WELLINGTON GREEN BID-RFI

July 25, 2016 responses are in red from WDA, Holland Engineering & Project Caine

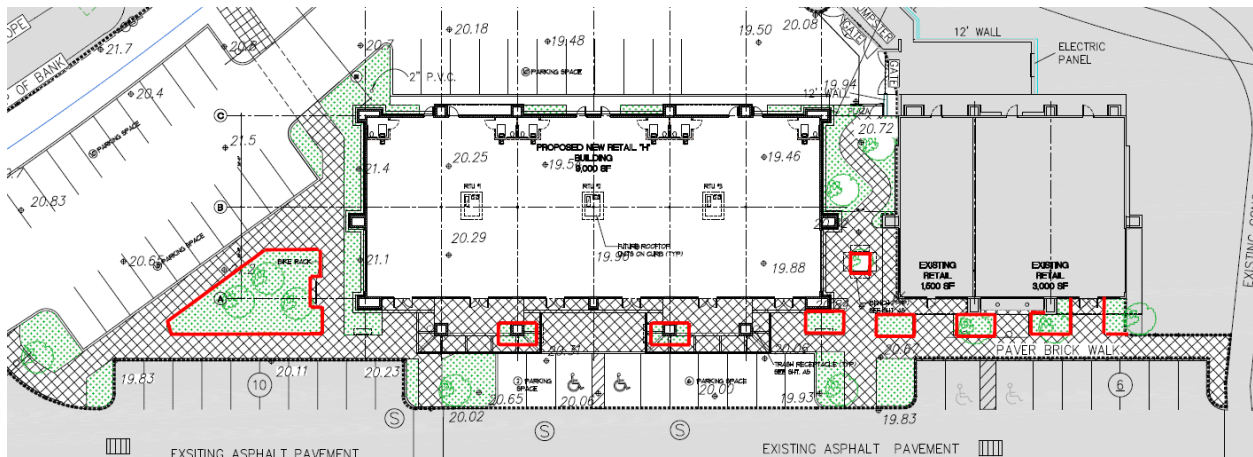
31. . The notes that show the existing 6" fire and 2" water are inverted. Meaning the existing 2" water is shown connected to the new 6" Fire DIP. See below. This will be corrected
